### **Amendments to the Drawing**

## REMARKS

### Status of Prosecution

FIGURES 4-5 OF MURRAY PATENT

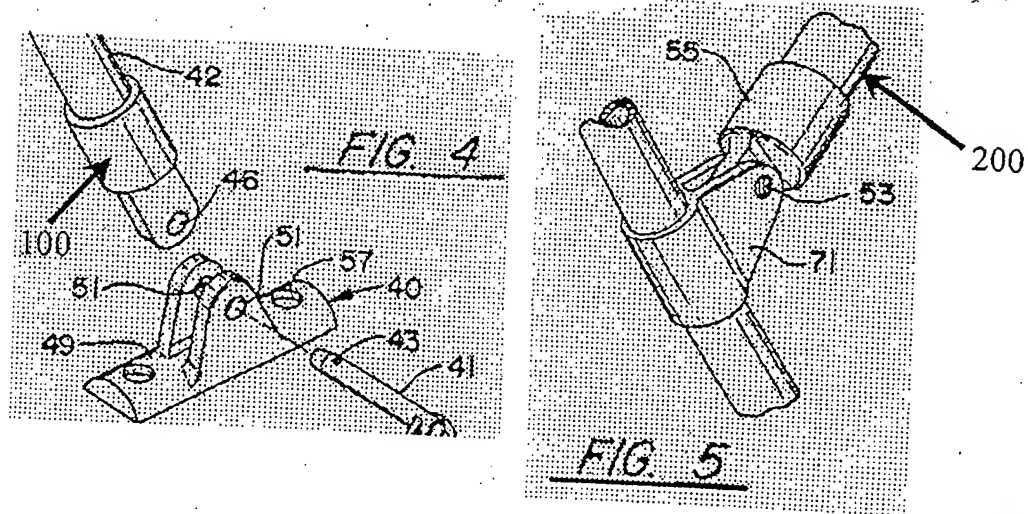
30 The apparatus of the Murray Patent is not universally adjustable. As is evident from the marked-up figures shown by the Examiner on page 4 of the Office Action, and reproduced on page 20 of this Reply, the component that the Examiner labeled “tub 100” allows leg 42 to be  
positionable in one plane only. Together, components 42 and 100 may rotate only in one plane around the axis formed when quick release pin 41 is inserted through apertures 52 (see Figures 4-5 of the Murray Patent, and column 3, lines 58-64).

20 B. Structural Disagreements Marked-up Figures 4 and 5 from the Murray Patent are reproduced for an additional reason. In the earlier Reopened Office Action the Examiner stated that Applicant "does not fully appreciate that figures 4 and 5 show separate sections of the assembly of figure 1." The Examiner went on to state: "Figures 1, 4 and 5, as depicted together above, show that element 100, while similar in structure to element 55, is in addition to and  
25 assembled away from element 55." (Emphasis added.) Applicant respectfully disagreed then, and raises this again to show how the structure and cooperation of structure of the Murray Patent and Applicant's coupler are completely different.

FIG. 5

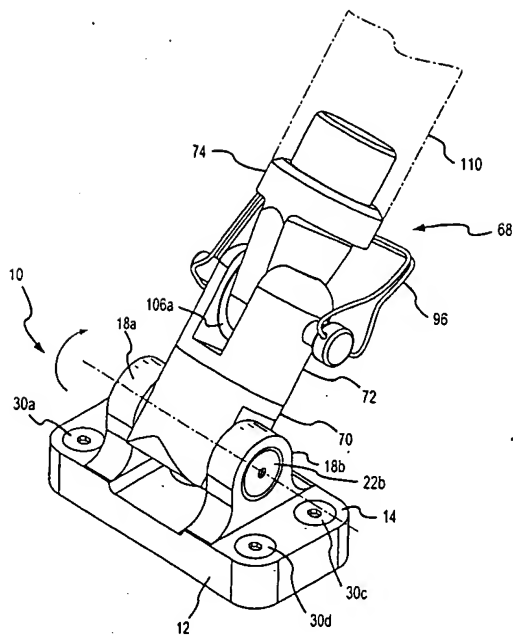
In Figure 5 a reference character “68” was deleted.

Figure 5 is a perspective view of the coupler showing possible variable positions;

FIG. 6

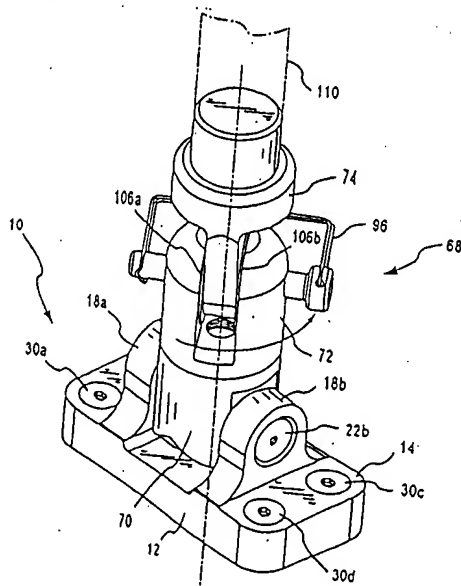
5 For Example, Figure 6, however, begins to demonstrate the mechanical departure of the coupler from the Murray apparatus. The semi-circular arrow shown on plug 72 of coupler 10 shows yet another of the variable positions of the coupler by showing that because of the unique use of plug 72 in combination and mechanical cooperation with neck 74 and tub 70, components of coupler 10 may also and simultaneously rotate around a y-axis. Figure 7 shows that a  
10 segmented portion of coupler 10, namely neck 74, may rotate around yet another z-axis. As indicated in the "Brief Description of the Drawing," Figure 8A shows that tub 70 may rotate around the axis formed by first threaded bolts 22a,b in opposing yokes 18a,b, while at the same time plug 72 may rotate in relationship to tub 70, while at the same time neck 74 may be variably positioned in yet another plane or direction -- all of which is shown again for emphasis from an

FIG. 8A

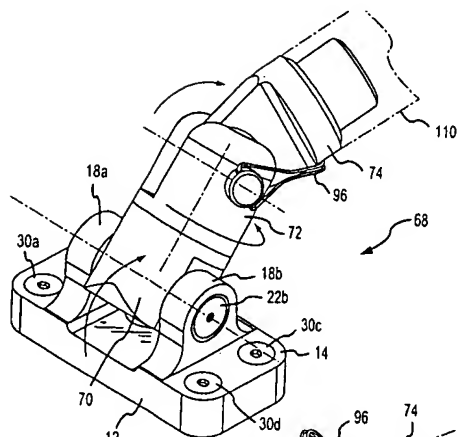
In Figures 8A and 8B reference character “10” was deleted.

Figure 8A is a perspective view showing another variable position of the coupler;

FIG. 8B

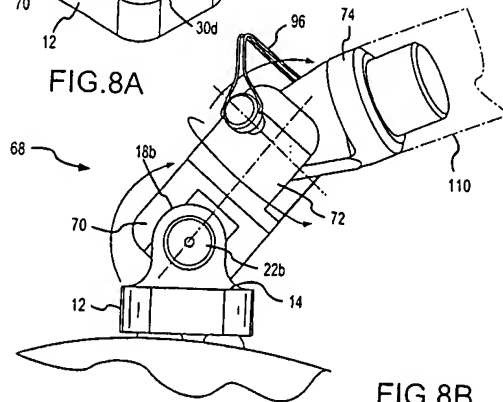
Figure 8B shows another variable position of the coupler on the ball washers...

15 alternative perspective in Figure 8B, which also demonstrates graphically that the flat bottomed base 12 is securely fastenable to a curved surface through the use of the ball washer assemblies 40.
